Access Compliance Report

Public Rights-of-Way

(Pedestrian Signals)

Intersection ID: N/A	Main Street:	Cross Street: N/A	Location: N/A
ADA ID: DC7A4C5DC561	Signal Type: Two Push Buttons-Non APS	Overall Compliance: No	Severity Score: BTN 1:N/A BTN 2: N/A No BTN: N/A
Codes/Mitigation Info/Possible Solution		Field Measurements/Component Compliance

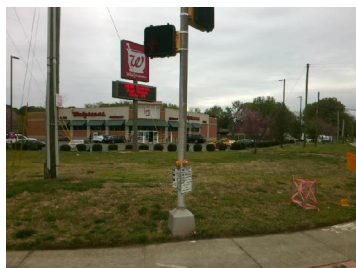
Possible Solutions: Replace Signal Push Button With APS Button on New Post. Remove & Relocate Sign. Remove and Replace Clear Space.

PROW/ADA: TMUTCD 4e.08, R404.2, R404.7.3, R404.7.2, R406.2, R406.3
